UNECE-R 22 - View of BAST

Bundesanstalt für Straßenwesen

Points for possible improvement

Impact speed

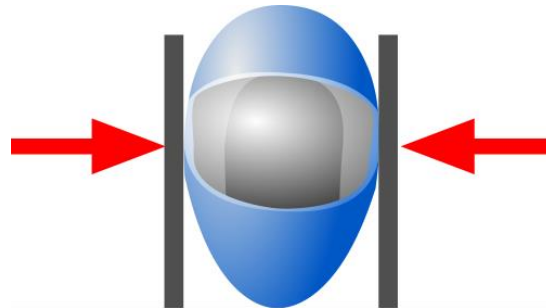
- The impact speeds in accidents are varying between low and high speeds
- For linear impacts the impact speed of **7.5 m/s is deemed reasonable**
 - Lower speeds would not represent the accident situation
 - Higher speeds could lead to stiffer helmets
- The ideal helmet would be able to protect at high and low speeds to address the severe as well as the slight but frequent injuries
 - > **low and high speed test in combination?**

Headforms (1)

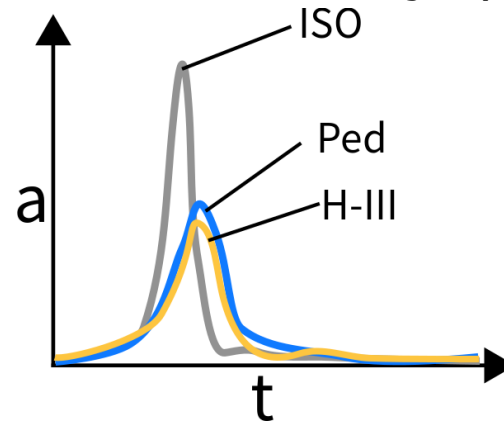
- Currently the headform is a rigid metal head with the upper portion of the neck
- The rigid and stiff structure transmits accelerations more than other headforms
 - > comparability of thresholds and injury mechanisms

Headforms (2)

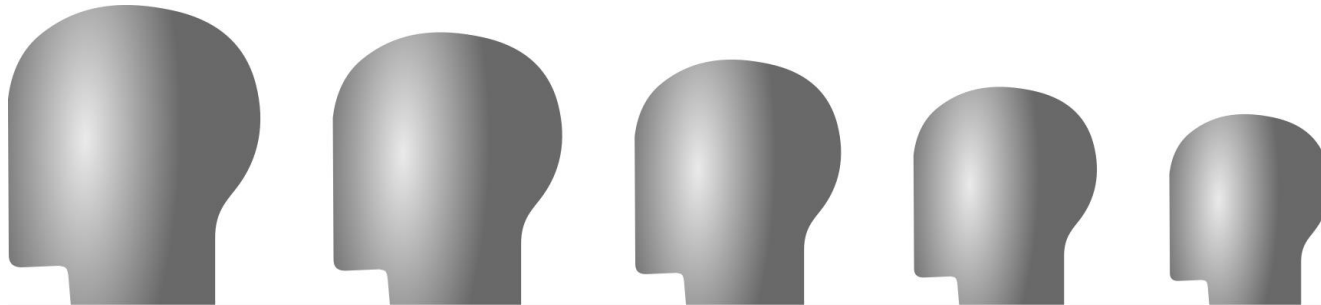
- Headform needs to accommodate sensors for **linear and rotational accelerations**
- Headform needs to have a **realistic moment of inertia, mass distribution, geometry and surface**
- Need to address **different sizes** of helmets and helmet fits

Headforms (3)

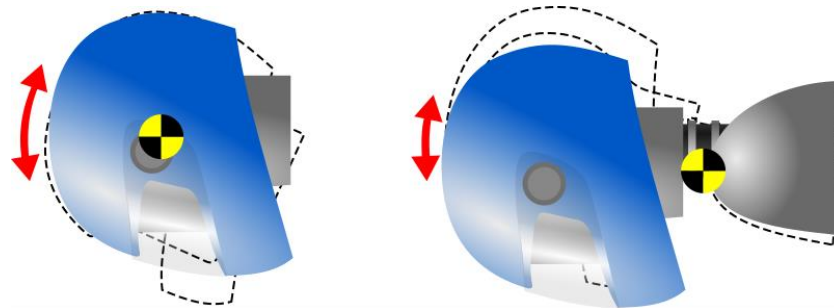
- The test describes a free fall with no limitation of movement
-> Head can spin due to the rotational components
- Investigation of the influence of an attached neck or body mass
- More realistic loading due to the neck and interactions?
- Neck relevant in the short period of impact?

Criteria and thresholds (2)

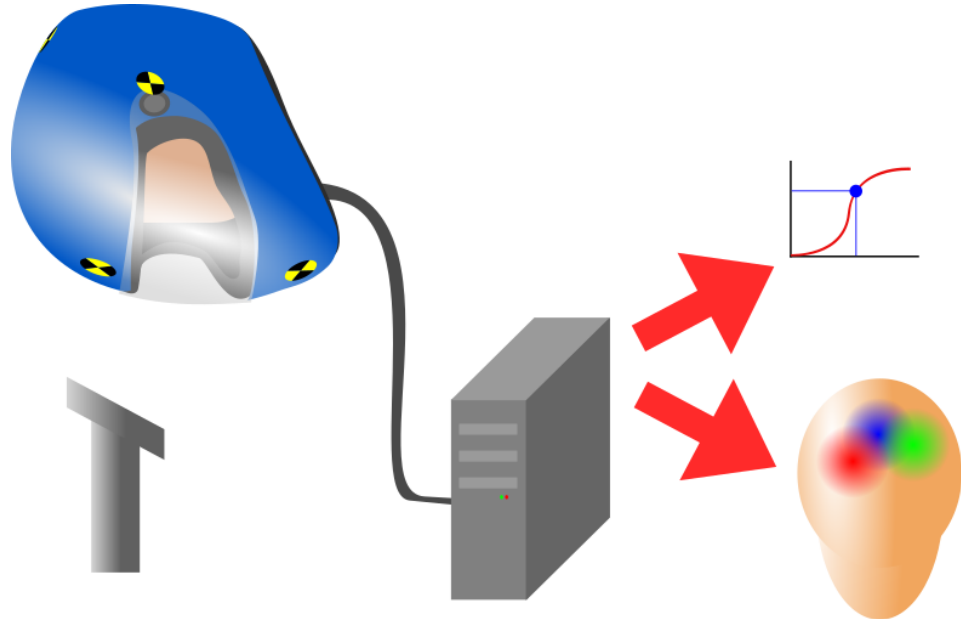
- Combination of physical test and simulation has to be discussed
 - Model
 - Measurements
 - Criteria
 - Validation
 - Availability
 - etc.
